UNITED STATES
DEPARTMENT OF THE INTERIOR
BUREAU OF LAND MANAGEMENT

SUNDRY NOTICES AND REPORTS ON WELLS
Do not use this form for proposals to drill or to re-enter an abandoned well. Use Form 3160-3 (APD) for such proposals.

Marathon Oil Permian respectfully requests approval to change the BHL for the Frizzle Fry BS Federal Com #502H as follows:
Approved BHL: 100' FNL & 1650' FWL Sec. 15-22S-32E
Proposed BHL: 100' FNL & 1775' FWL Sec. 15-22S-32E
Anticollision concerns required a lateral path move & BHL move of ~ 125'. Please see revised directional plan, revised drill plan & revised C102

Well Name: FRIZZLE FRY BS FEDERAL COM	Well Location: T22S / R32E / SEC 22 / SWSW / 32.3707651 / -103.667135	County or Parish/State: LEA / NM
Well Number: 502H	Type of Well: OIL WELL	Allottee or Tribe Name:
Lease Number: NMNM077058	Unit or CA Name:	Unit or CA Number:
US Well Number: 3002549555	Operator: MARATHON OIL PERMIAN LLC

Project: Lea County, NM (NAD27 NWE)
Site: Frizzle Fry
Well: Frizzle Fry BS Fed Com 502H
Wellbore: OH
Design: Plan 1 05-29-24
Rig: Cactus 171

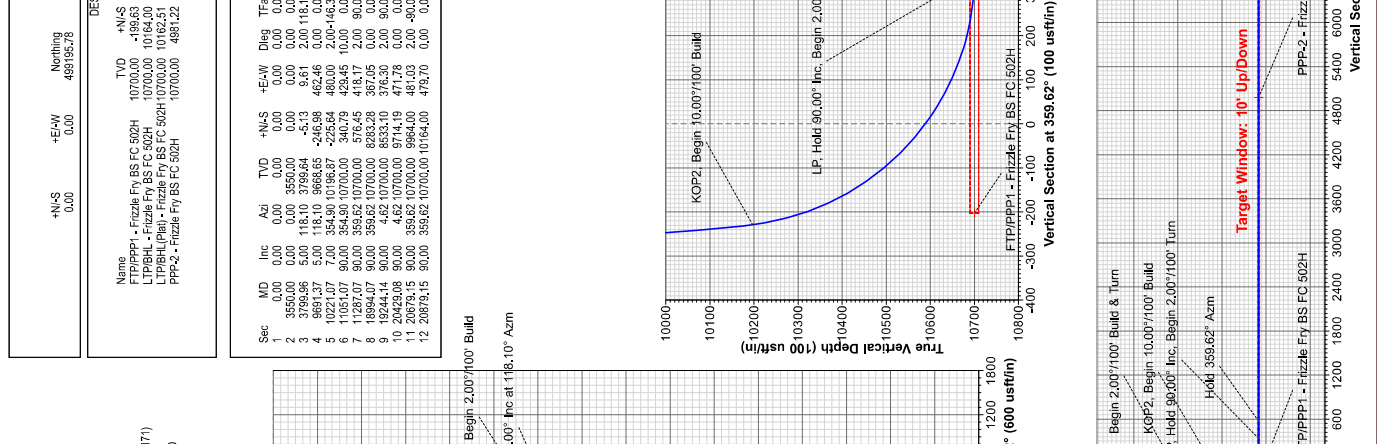
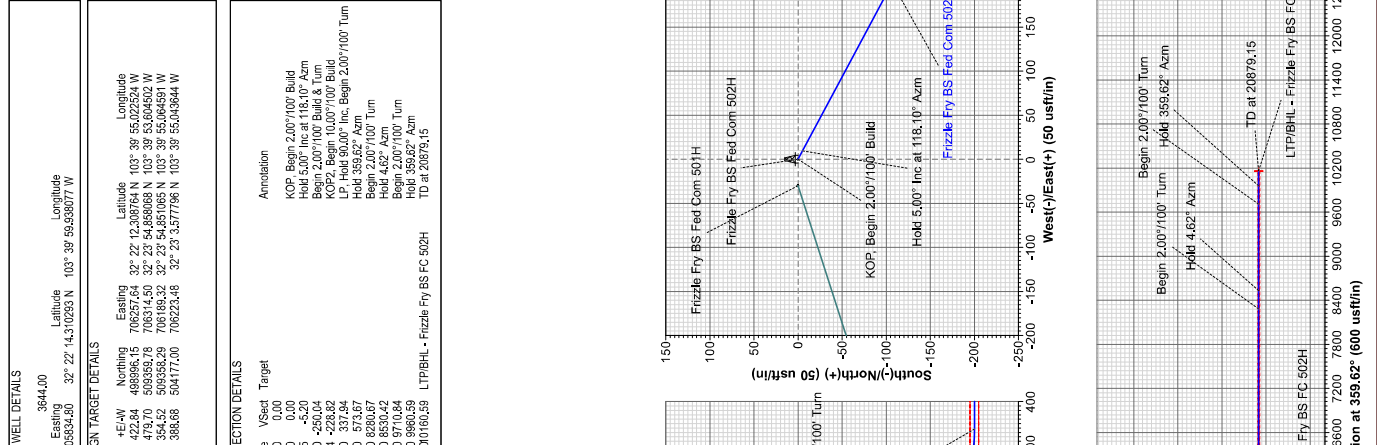
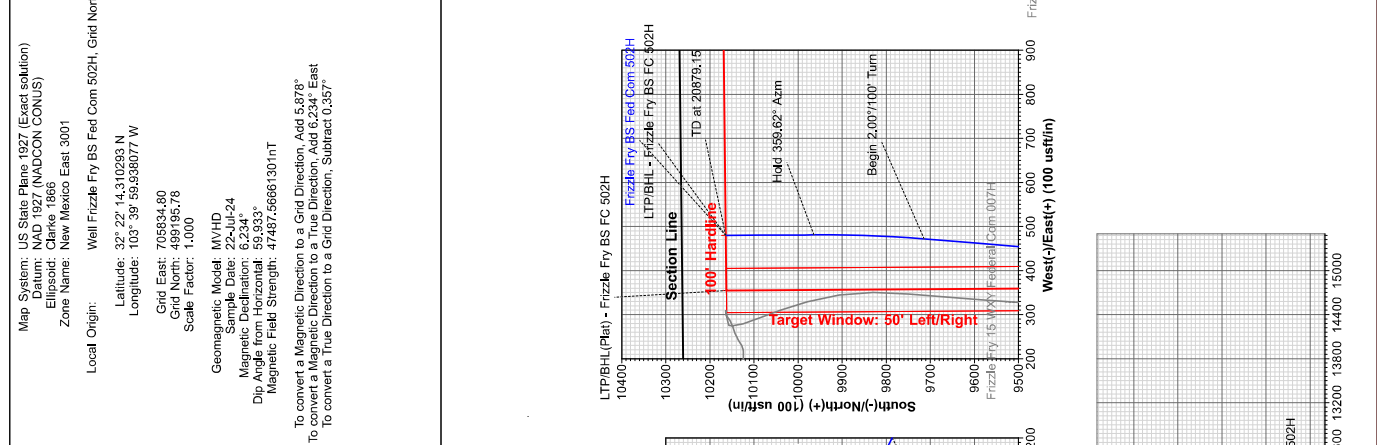
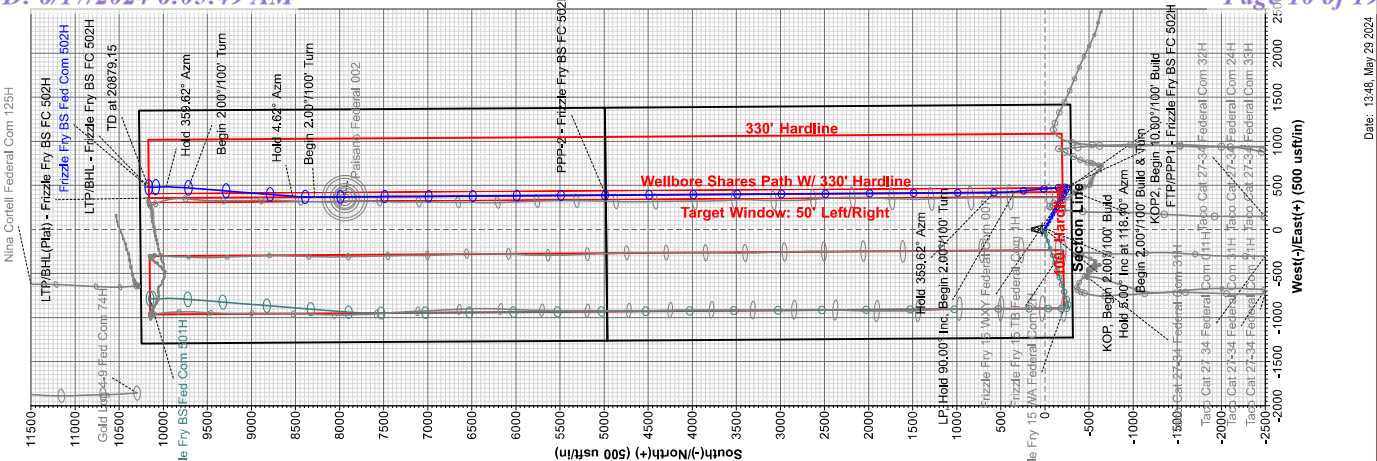
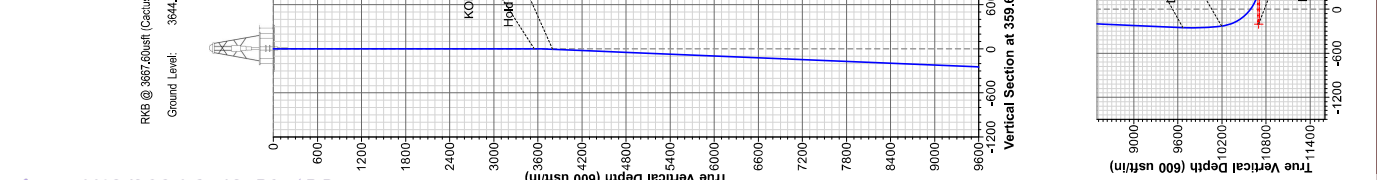
Procedure Description: Marathon Oil Permian respectfully requests approval to change the BHL for the Frizzle Fry BS Federal Com #502H as follows: Approved BHL: 100' FNL & 1650' FWL Sec. 15-22S-32E Proposed BHL: 100' FNL & 1775' FWL Sec. 15-22S-32E Anticollision concerns required a lateral path move & BHL move of ~ 125'. Please see revised directional plan, revised drill plan & revised C102

- plan misses target center by 125.19usft at 20878.49usft MD (10700.00 TVD, 10163.34 N, 479.70 E)									
- Rectangle (sides W100.00 H10,362.30 D20.00)									
LTP/BHL - Frizzle Fry	0.00	359.62	10,700.00	10,164.00	479.70	509,359.78	706,314.50	32° 23' 54.858068 N	3° 39' 53.604503 W
